RE: P-2114-WA - Priest Rapids Hydroelectric Project, Wanapum Dam Spillway Monolith No.4 – Request for approval of Interim Fish Passage Operations Plan.

Interim Fish Passage Operations Plan

Appendix C
Agency and Tribal Representative Comments/Recommendations Summary Response
Table for Interim Fish Passage Operation Plan

Figure 2 Proposed modifications at the Priest Rapids Off-Ladder Adult Fish Trap to facilitate the water-to-water transfer of adult salmonids to a transport vessel.

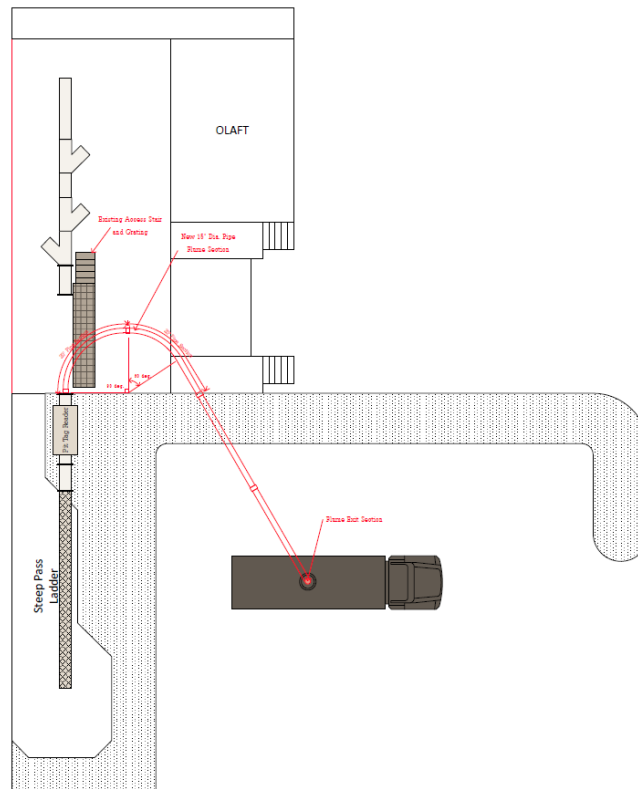
Colville Confederated Tribes	Kirk Truscott	3/18/2014	Comment 6	Flume entry in to the transport trucks needs to be constructed such that the fish don't slam into the sides of the truck.	Agreed. Designs currently being considered are installation of a rubberized boot from the pipe to the truck hatch, such as those used on fish pumps.
Colville Confederated Tribes	Kirk Truscott	3/18/2014	Comment 7	Lamprey passage at the false weir may be poor and may be the capture at the PRD OLAFT, as such trapping efforts in the PRD ladder should be considered to aid in the trap and haul of lamprey.	Please note the lamprey passage plates on either side of the weir shown on page 1 of the conceptual drawing. Essentially these reduce the weir length by 2 feet. We have increased the opening of the weir grating from 1/2" clear to 3/4" clear (1/2" bar @ 1.25" c to c) in order to maintain the desired velocity/flow coming out of the bar grating. Grant PUD will continue to consult with PRFF on lamprey passage.

REV	DATE	NATURE OF REVISION	BY	APPD	APPD
FOR Grant County PUBLIC UTILITY DISTRICT					
WEIR BOX PLAN AND ELEVATION					
DRAWN BY #	DATE DRAWN #	SCALE #	CHECKED BY #	PROJECT NUMBER WA-LW-S01-0	SHEET NO. 5 OF 5

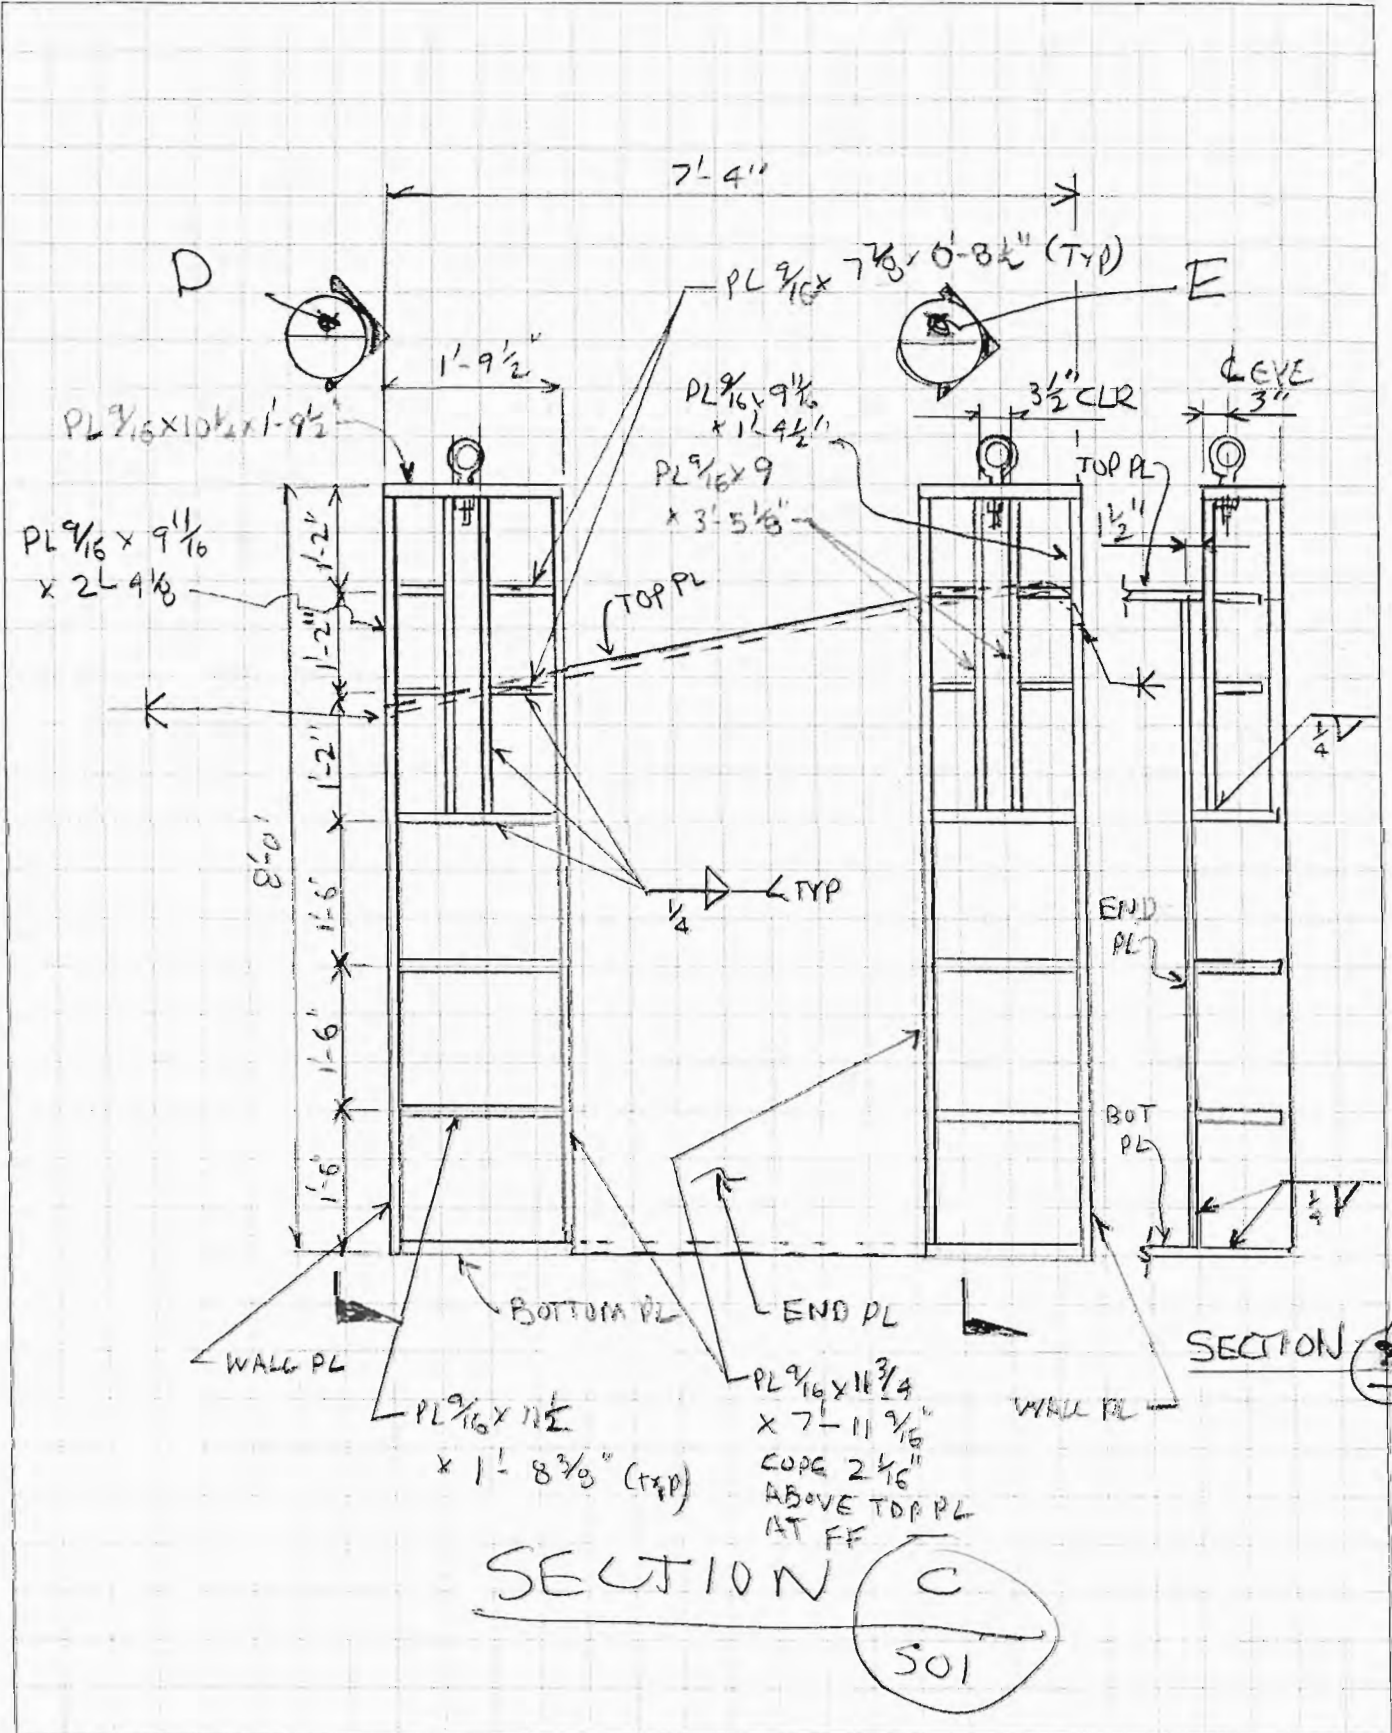
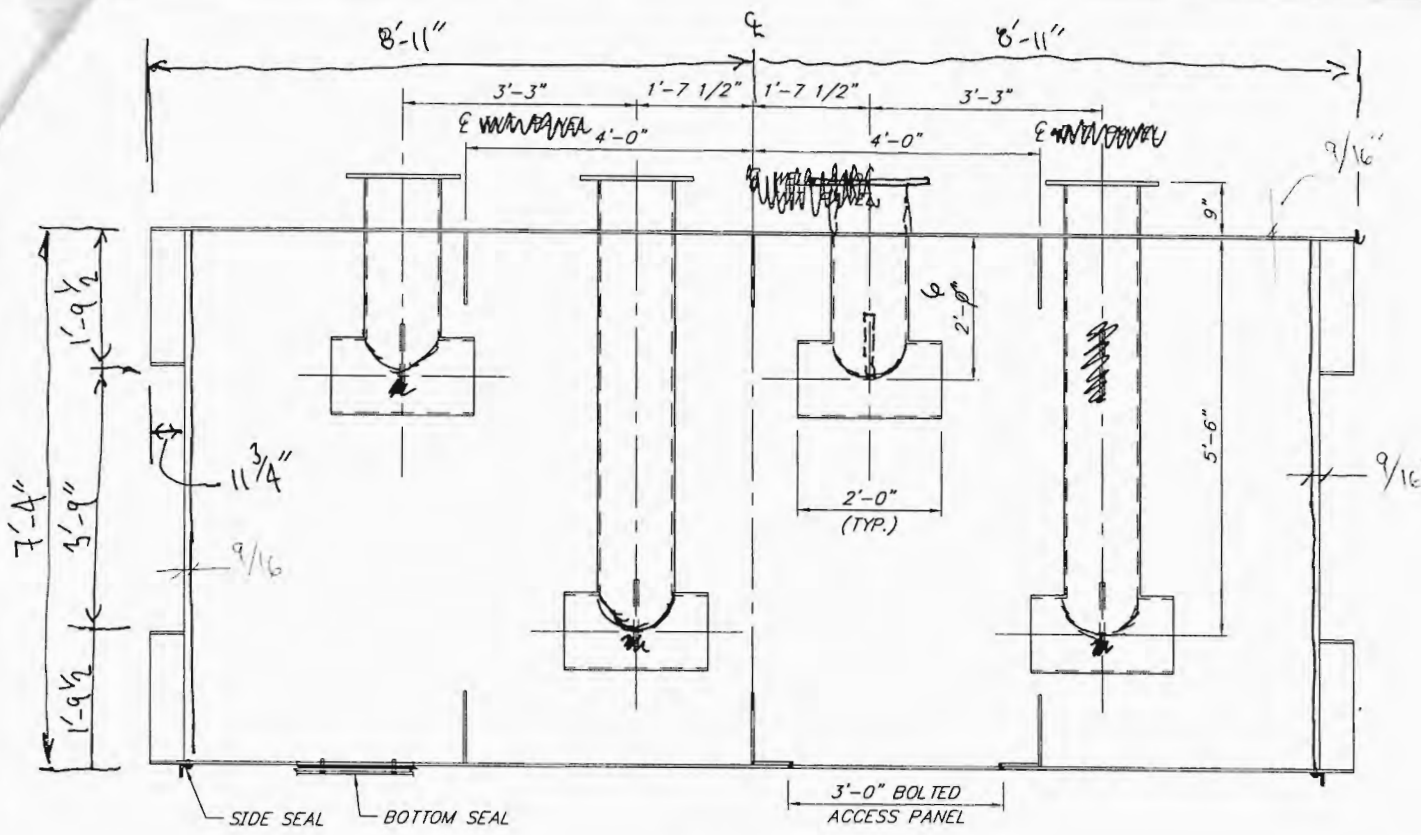
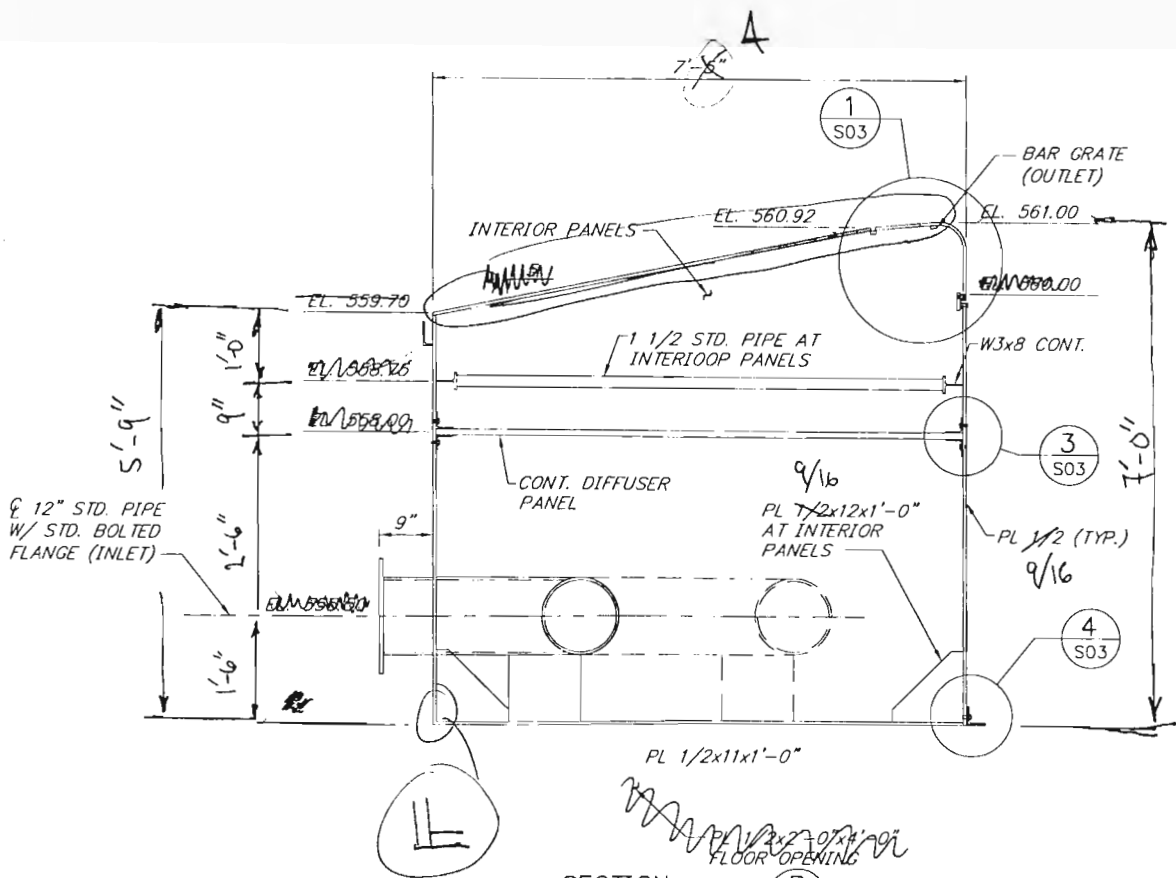
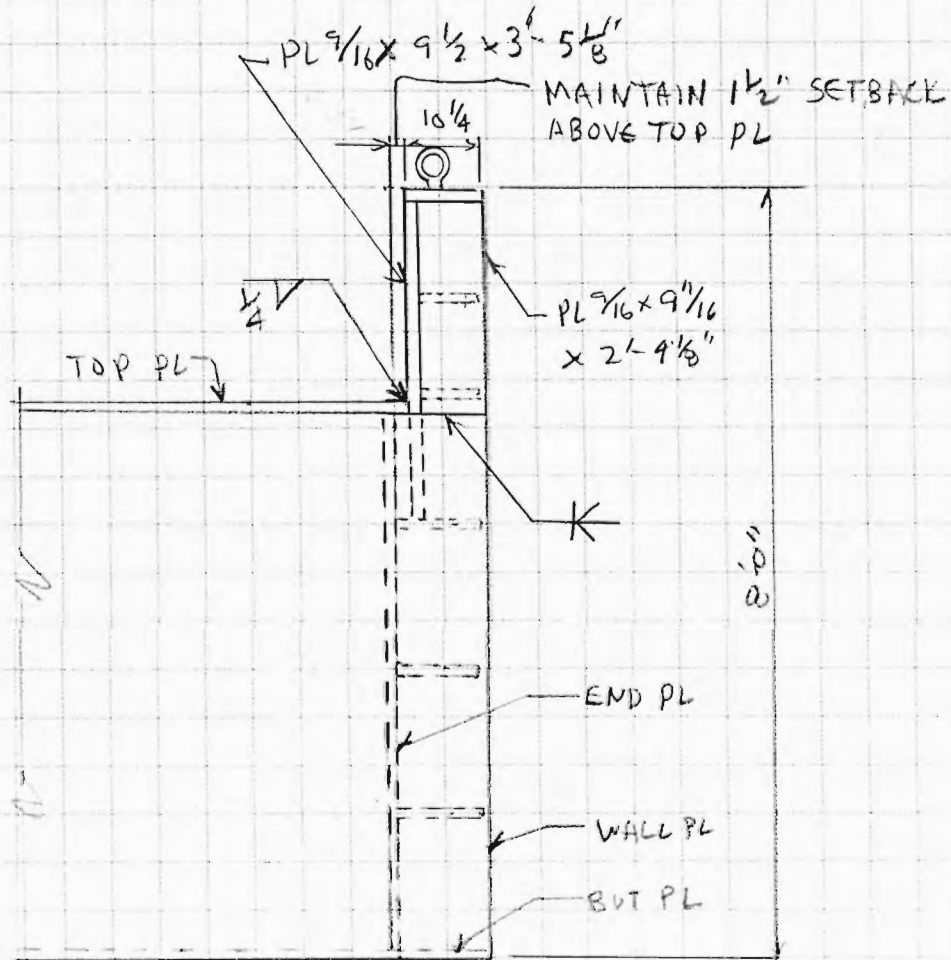
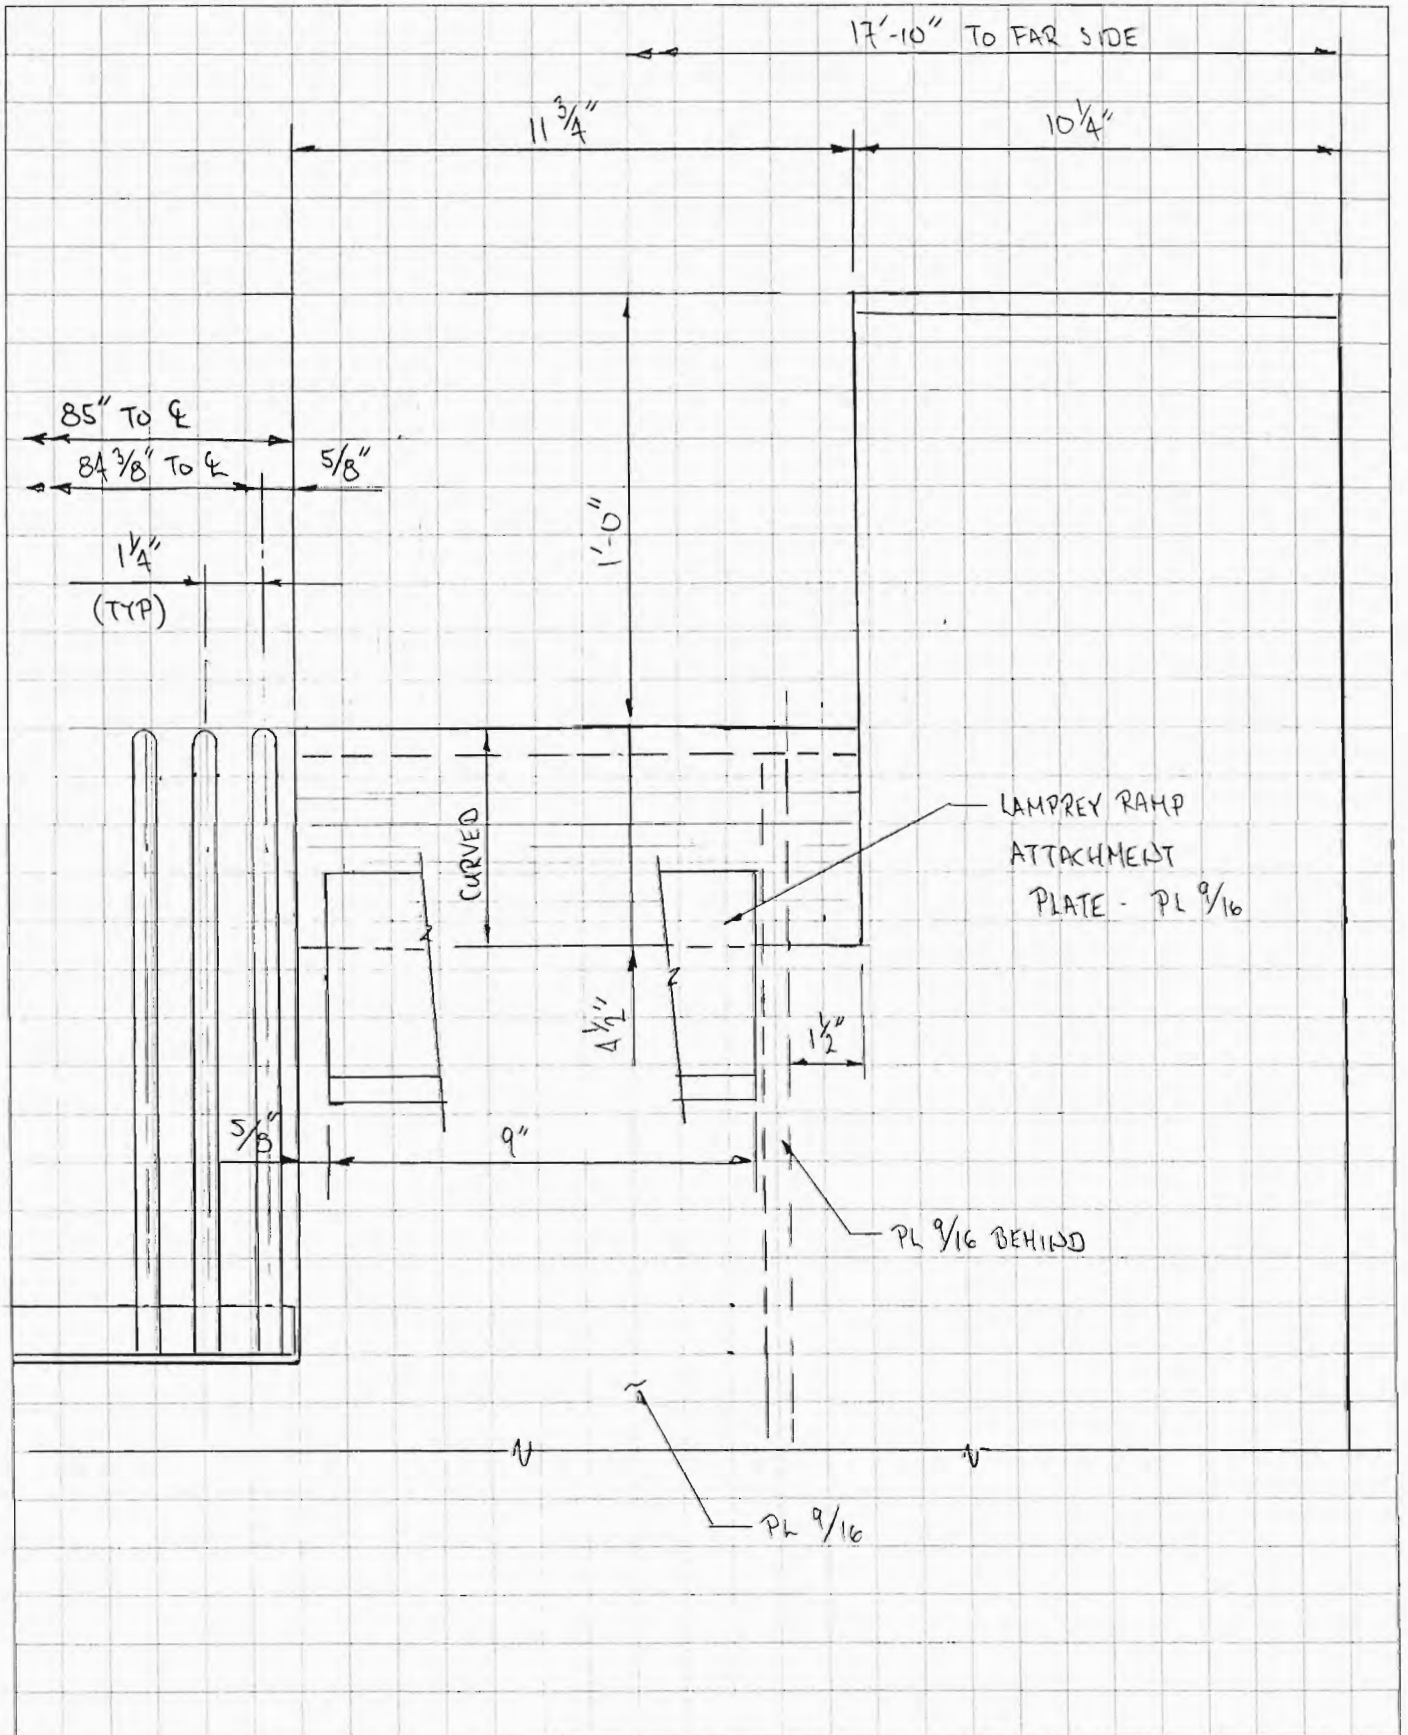
U.S. Fish & Wildlife Service	Stephen Lewis	3/14/2014	Fish ladder modifications	There are many existing designs available for spiral chute exits. Is it possible for another manufacturer to replicate this same design in some manner since it's been in existence since the early 60s?	Grant PUD is currently working with Bryan Nordlund (NOAA Fisheries) on an acceptable chute design as a contingency (Phase II) to the current design (Phase I). Designs and fabrication for both the existing design and the contingency design will move forward in parallel. The Phase I design will be installed and monitored.
U.S. Fish & Wildlife Service	Stephen Lewis	3/14/2014	Fish ladder modifications	We discussed this a bit, but what is the coating of the ramp leading to the proposed PVC chute?	Chute will be made of Fiber Reinforced Plastic (FRP). This will provide a smooth surface. This material is used in the fabrication of current fish transport tanks.

U.S. Fish & Wildlife Services	Stephen Lewis	3/14/2014	Fish ladder modifications	Is there a contingency plan in the event more makeup water is needed to execute this modification?	The upper orifice walls are designed to flow 70 cfs through two orifices. We plan to block one of the orifices in the walls all together thus requiring about 35 cfs for a 12” drop to the next orifice wall. The lower weir walls are designed to flow 30 cfs through the lower orifices and 40 cfs over the weir. We should see a full orifice and some water over the weir at this location. If more water is needed down the fish ladder, there is the ability to adjust the weir plate.

U.S. Fish & Wildlife Service	Stephen Lewis	3/14/2014	Fish ladder modification	It's assumed this modification will function at forebay elevations ranging from 541'(3)-560'(58)?	The elevation of the fish ladder exit is 554'. Once the forebay reaches elevation 551' we will need to remove the weir and chute and the orifice blocking plates then continue to raise the forebay to 560-562'. This will require a short outage to remove the equipment.
U.S. Fish & Wildlife Service	Stephen Lewis	3/14/2014	Fish ladder modifications	The tailwater of Wanapum will likely fluctuate somewhat due to normal interim operations and Hanford Reach protection flows, so will these operations affect the functionality of this modification?	Our auxiliary water system forebay inlet has an elevation of 525'. The system will still be able to provide adequate attraction flow into the tailrace to attract fish to the entrance. The flow curves of the auxiliary water system have been checked. We should be able to keep fish ladder entrance in compliance with current criteria, but this has not yet been tested at this forebay elevation.

U.S. Fish & Wildlife Service	Stephen Lewis	3/14/2014	Fish ladder modifications	We encourage any rounding corners that may be possible during this modification to encourage lamprey passage in the event spillway repairs take longer than expected and extend into the lamprey passage timeframe.	We have designed lamprey ramps up and over the weir and will radius corners to reduce impacts to fish/lamprey passage.
U.S. Fish & Wildlife Service	Stephen Lewis	3/18/2014	Salmon & Steelhead	We understand that a "false weir" structure and accompanying ramp will be used at Wanapum Dam to convey fish upstream into the Wanapum forebay at its current water elevation ranging from 541 feet to 543 feet. The Plan does not clearly state whether or not a transition chute will be used during the initial installation to minimize injury to fish. We recommend installing this	Grant PUD is working with Bryan Nordlund (NOAA Fisheries) as the Priest Rapids Coordinating Committee technical expert on a two-phase approach. Wanapum Dam ladder Phase I is installation of the current flume system design that will have an exit elevation of 554'. With a forebay operating range of 541' to 545', the maximum vertical drop fish would encounter would be 13'. Grant PUD has also provided B. Nordlund with a report on adult salmon dropped from 35' with 100% survival. Based on observational data and in consultation with NOAA and USFWS, a decision will be made on whether to proceed with an alternative design (Wanapum Dam ladder Phase II).

- We understand that a "false weir" structure and accompanying ramp will be used at Wanapum Dam to convey fish upstream into the Wanapum forebay at its current water elevation ranging from 541 feet to 543 feet. The Plan does not clearly state whether or not a transition chute will be used during the initial installation to minimize injury to fish. We recommend installing this transition chute extension during initial installation rather than deferring this action further into the various fish passage timeframes. This chute should be designed to minimize the impact to fish below the 25 feet per second threshold as they enter the forebay at its current water elevation.

- While we appreciate Grant PUD's efforts to modify the false weir to convey adult lamprey upstream of Wanapum Dam, the likelihood of 100% passage is not guaranteed. We foresee lamprey ascending the weir and collecting on the transition ramp, and not necessarily sliding into the forebay at its current location. As such, we recommend Grant PUD personnel collect lamprey at this location and convey upstream depending on the functionality of the upstream fish passage modifications at the Rock Island Dam.
- Due to the high level of uncertainty associated with lamprey passage at the Project at this time, we recommend Grant PUD begin the development of a trapping program to convey lamprey above the Rock Island Dam.
